**Dane County, Wisconsin**  
**Telecommunications Site Review**  
**New Support Structure**

March 18, 2019

**RE: Review of Dane County Conditional Use Permit Application #2456 by Bug Tussel  
Wireless / Town of Montrose**

**Exhibit A - Proposed Support Structure**

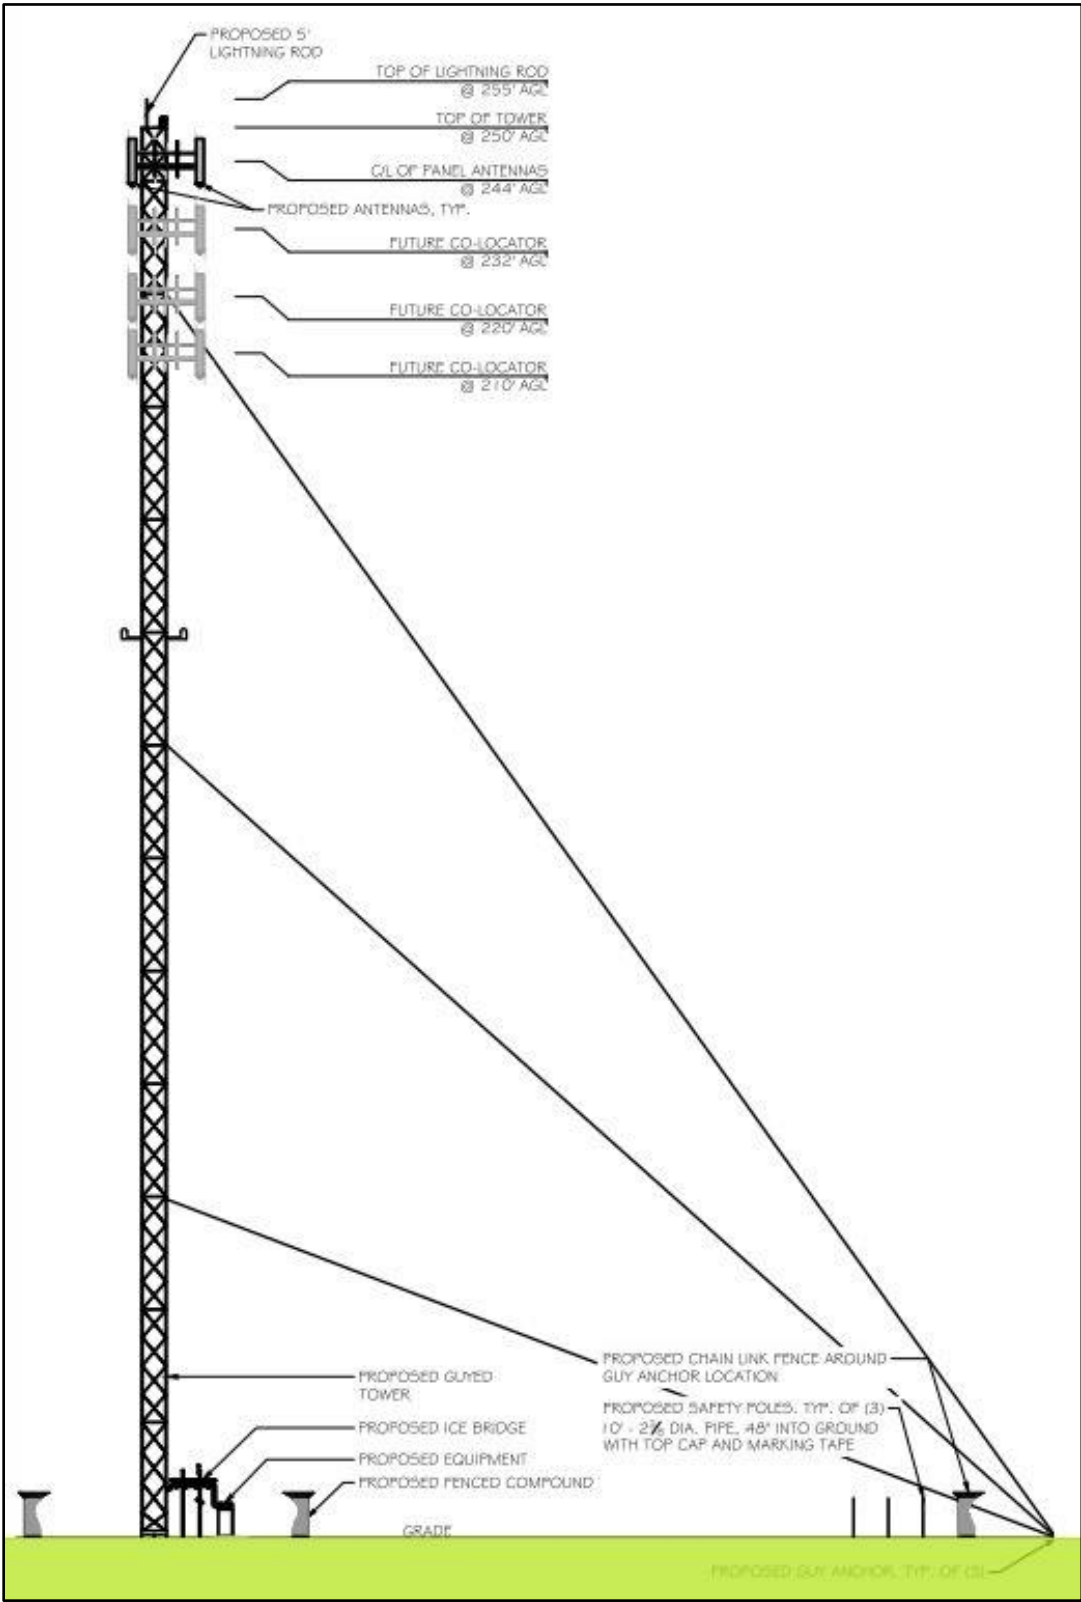
For a new wireless communications facility to be justified, its need, location and height must be addressed. The applicant proposes to construct a new two hundred fifty-five (255) foot *guyed* tower, *see Appendix, Exhibit A*. The proposed site coordinates are not listed on the drawings but are shown in the engineering study and on the CTIF (County form). However, these coordinates differ slightly and neither appear to match the location on the site plan. Therefore, for purposes of this report, CityScape will assume the following coordinates, based on review of the site plan: 42.88134 N, 89.58786 W.

### Exhibit B – Conflicting Search Rings

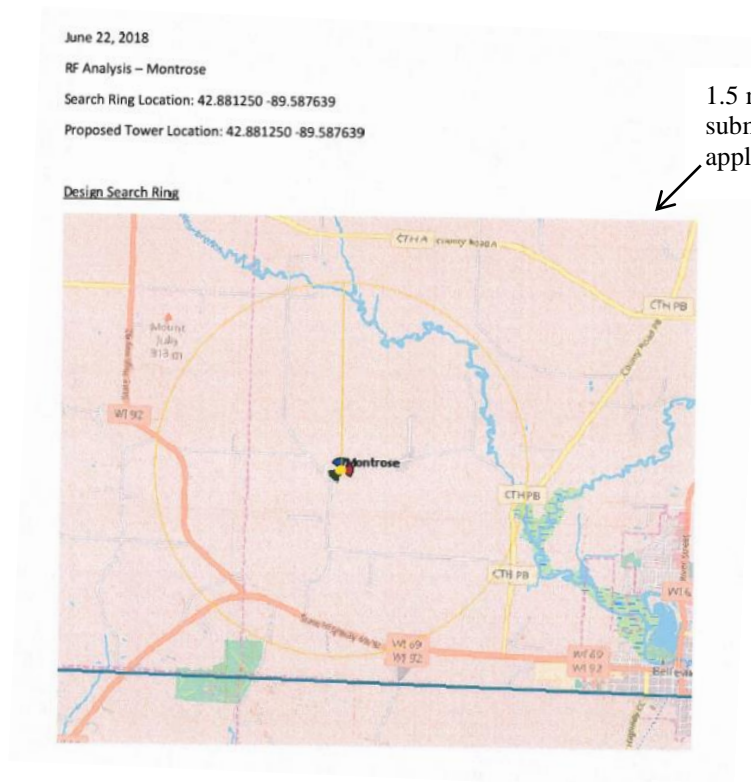
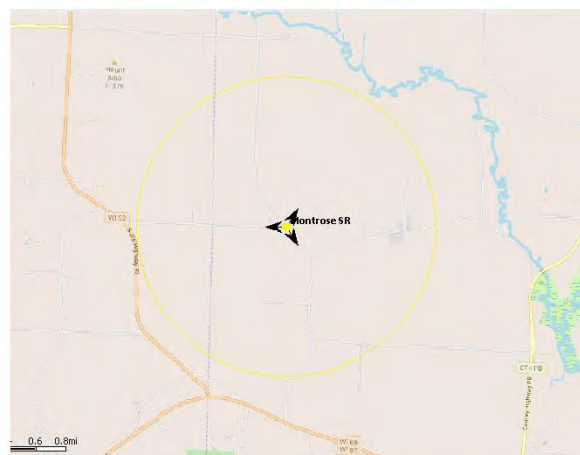
a new search ring. The “new” search ring provided in the December 12, 2018 filing is reduced in radius from 1.5 miles to 1.0 mile and is shifted about ¼ mile northwest of the proposed tower, *see Appendix, Exhibit B*.

However, the December 12, 2018 materials include plots of both rings. Since this new ring is smaller and centered further from the SBA tower, the SBA tower is no longer within the ring. An email from the Applicant noted that the search ring has changed over the last couple of years and that an older RF analysis was included with the incorrect ring. This is also puzzling since it was included in the June 2018 affidavit, relatively recently.

When the County asked for an explanation for the change in the ring’s size and location, a third affidavit was provided, dated January 7, 2019 modifying two items. Item number 5 of the affidavit was edited to state that a tower was found outside the search ring, identified as the SBA tower and that it was beyond the desired 1.5-mile distance from Montrose. Number 6 was also modified to include confirmation that AT&T will install FirstNet equipment on the tower. Copies of the 3 sworn statements can be found in Exhibit C of the Appendix.

**Exhibit C – Coverage Radius\***

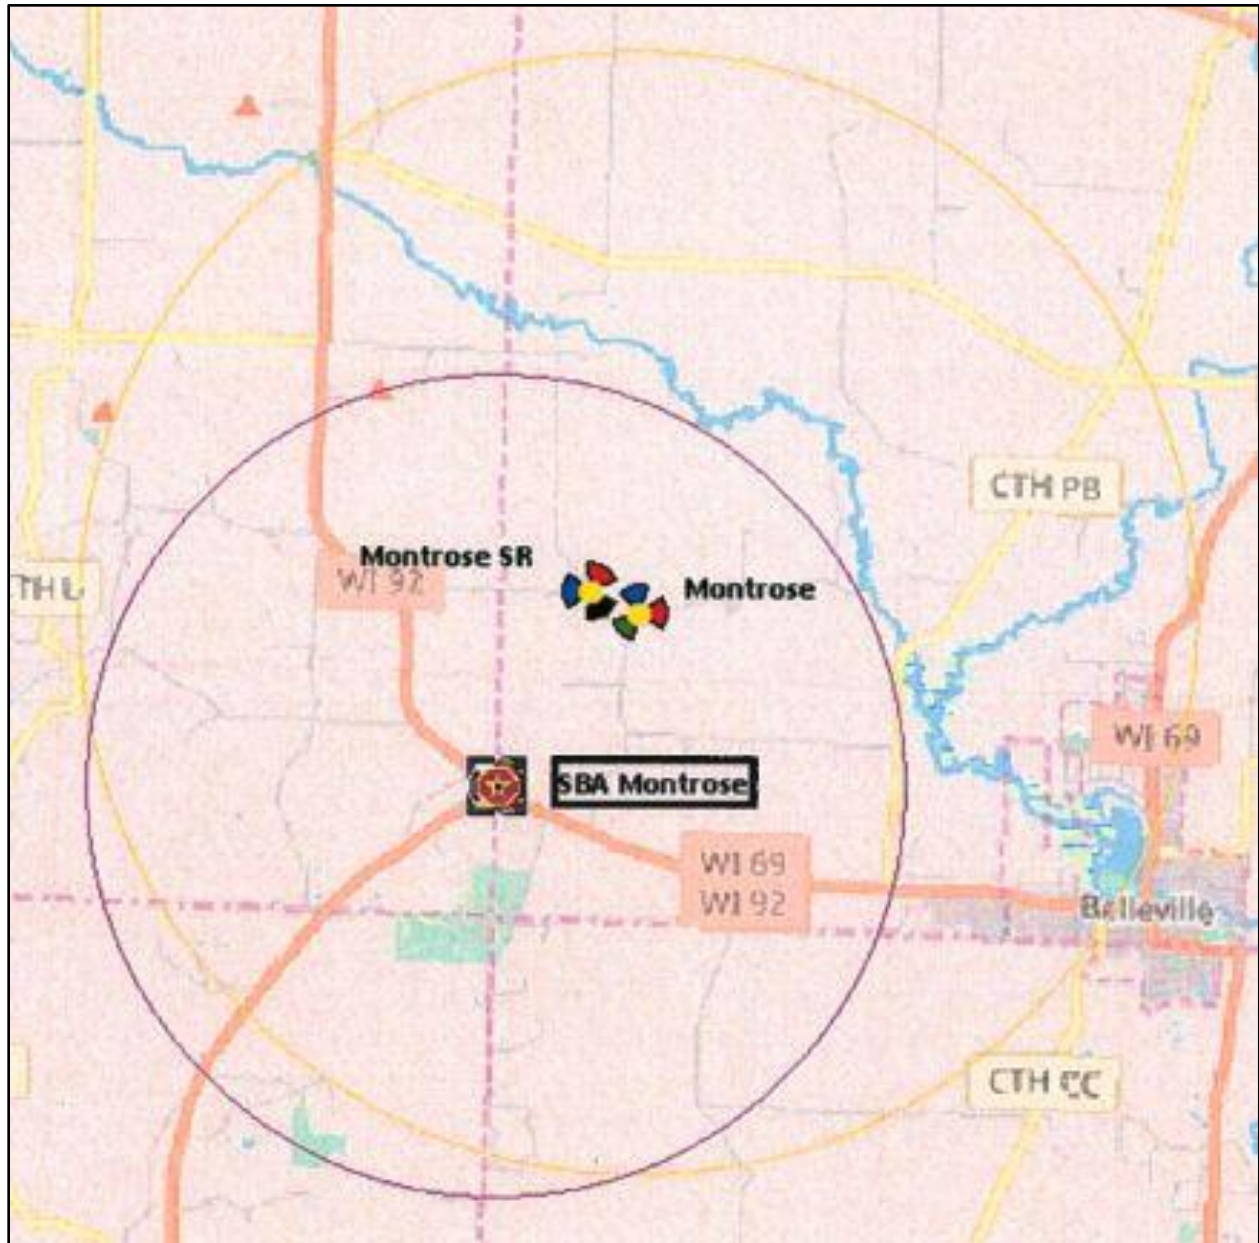
The coverage plots provided by the Applicant also compare the service from both locations. The coverage radius map shows circles, or coverage radii for both sites, *see Appendix, Exhibit C*. The smaller circle has a 2-mile radius and represents the coverage from the SBA site while the larger circle is 3 miles and represents the proposed site. These circles are most likely calculated using only the tower height without consideration of terrain or effective antenna height. Thus, this map is an inaccurate illustration of coverage.

\*CityScape staff believes that the provided coverage circles are based only on the tower height and not the effective antenna height, which includes ground elevation and would result in coverage that is not a perfect circle. CityScape therefore questions the validity of the predicted difference in coverage.
